**FINDING OF NO SIGNIFICANT IMPACT**  
**Desimone-Briscoe School Levee Rehabilitation**  
**Tukwila, Washington**

APPENDIX A: Site Photos, Project Designs, and Pullout Pit Illustrations

Bobbi Jo McClain Ecology Comments on NOP, Attachment B, March 9, 2015 | Page 12

Figure 3. Project site details. The yellow shaded area indicates the Federal Action.

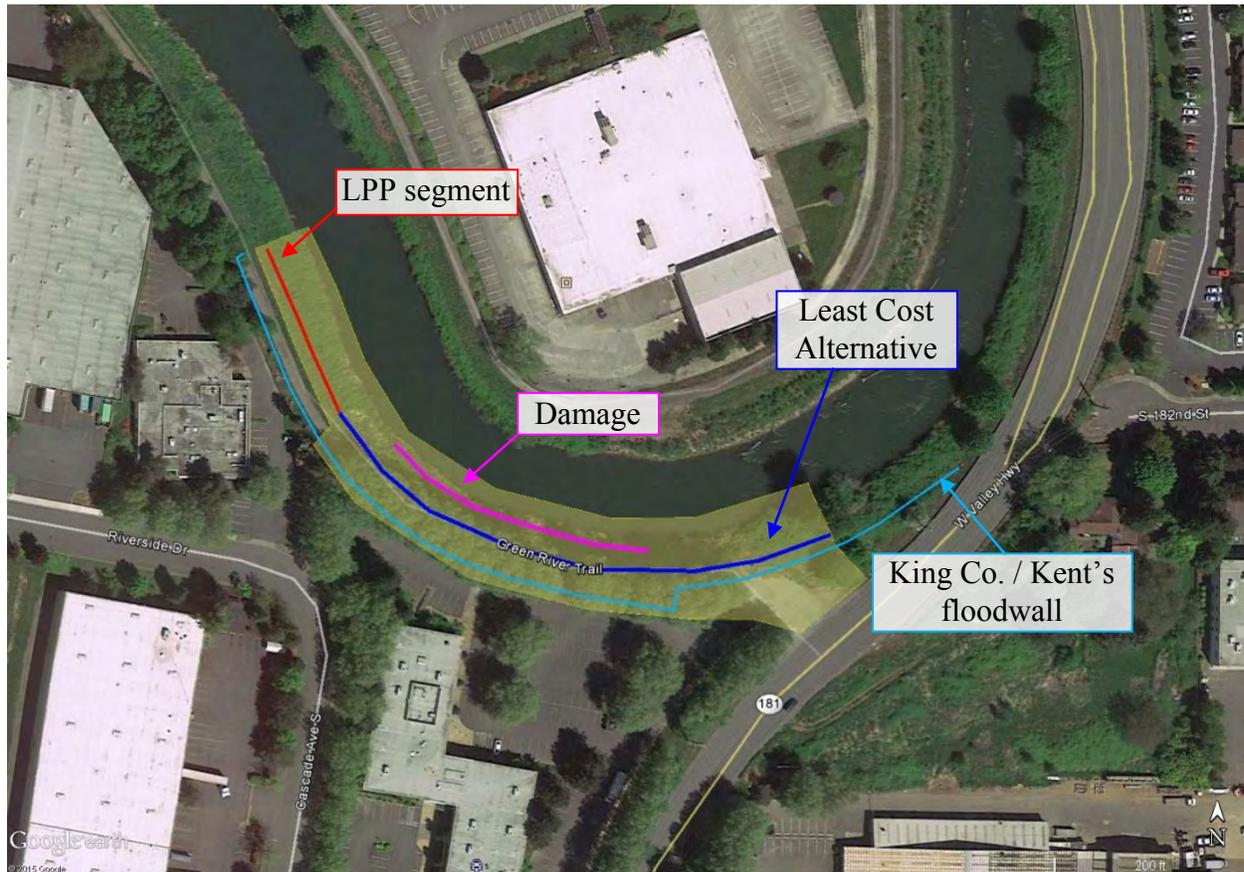
The planting proposal shown in NOP Figure 3 is not adequate to meet river temperature requirements. The project plan and design as a whole should be modified to provide a much wider and more suitable tree planting area and soils between the floodwall and the river to help address the river temperature impairment, and a new plan provided for review. The trail should be narrowed to the existing 10 feet to maximize space for trees and riparian plants to fully mitigate for the loss of the existing trees and to address the critical riparian shade needs at this site. A larger planting area is needed to accommodate a minimum of 170 trees as required under the local sponsor's City of Tukwila Shoreline Permit (#L14-0030) issued August 20, 2014.

Figure 1. Project site details (approximate – see designs for specific, accurate location). The yellow shaded area indicates the Federal Action.

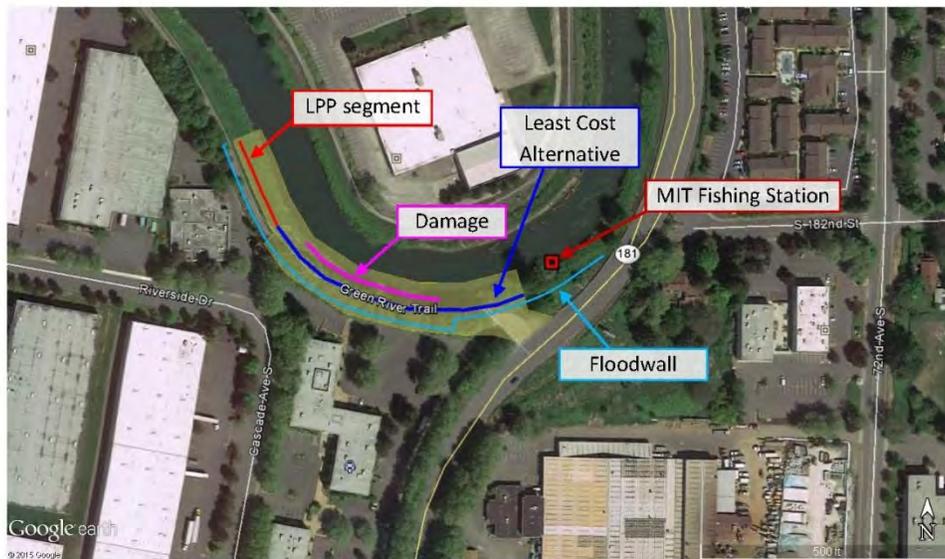
<b>Corps</b>			
	<b>Project Feature</b>	<b>Specification</b>	<b>Notes</b>
	Length (See Figure 1)	775 ft*	585 ft (Least-cost) 190 ft (LPP)
	Armoring	Throughout	to the 100 yr level of protection elevation
	Layback final slope (low)	2:1	
	Layback final slope (upper)	1.5-2:1	With an upper slope bench
	Green River Trail width	16 ft	
	Tree removal (see Figure 2)	17	Federal (to be off-set within the least cost project length only)
		15	Non Federal
		TOTAL: 32

\*Note: The Federal project is broken into several pieces. The full length of riverward work is 775 ft. This is made up of 585 ft of "Least-cost alternative" plus 190 ft of "Locally Preferred Plan (LPP)". The least-cost alternative is what the Federal action would be to repair the damage (slope layback and toe work, as well as a retaining wall). King County requested the toe and slope work be lengthened 190 ft upstream, in order to continue the armoring in front of the remainder of the upstream floodwall installation. See Figure 1 below for further explanation. The cost increase due to the additional length of the LPP would be borne solely by the local sponsor. The Federal action, and consideration of impacts, includes 775 ft of riverward work and 585 ft of floodwall installation. However, because King County will be fully funding the extra 190 ft of work, any trees planted in that area would not be used as mitigation for the Federal impacts. We expect to continue the same tree/shrub planting plan throughout the full 775-foot repair, partially as Federal mitigation and partially available for non-Federal mitigation (should they choose to use it).
